SUNDRY NOTICES AND REPORTS ON WELLS

MOC Federal #4

OXY USA WTP LP
MOC Federal #4- Lease # NM-04827-B
API No. 30-015-28071

Temporary Abandonment of Wells on Federal Lands
Conditions of Approval

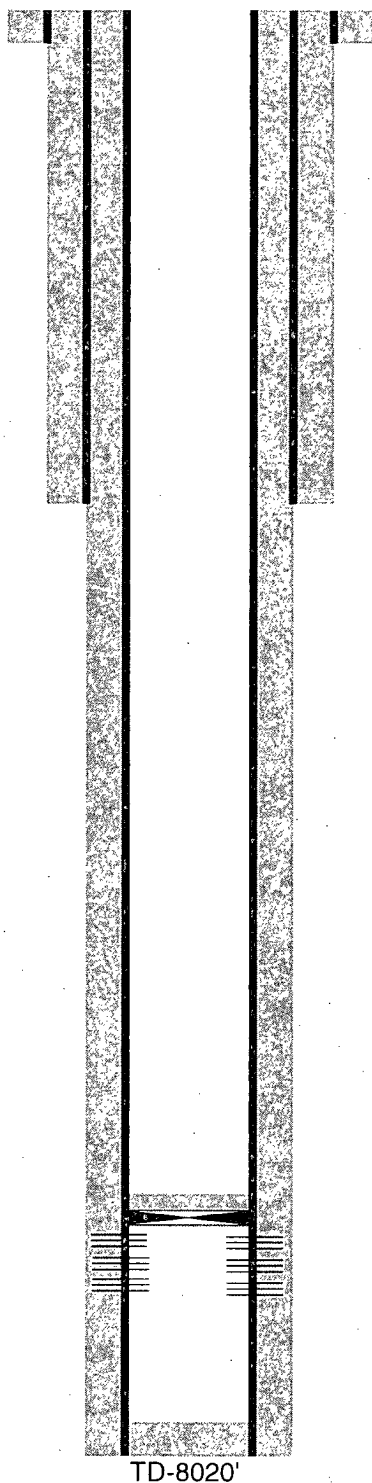
OXY USA WTP LP request an extension of the T/A for a period of 1 year. The subject well is located in the OXY YESO recomple pilot.

OXY request to MIT the well per rules

TD:8020' PBDT:7426' CIBP:7436'

See attached Wellbore Diagram

MOC Federal #4. Well may be approved to be TA/SI for a period of 1 year or until 12/30/2011 after successful MIT and subsequent report with well bore diagram is submitted. Approval subject to annual Plan of Development review and approval for the Yeso development area.
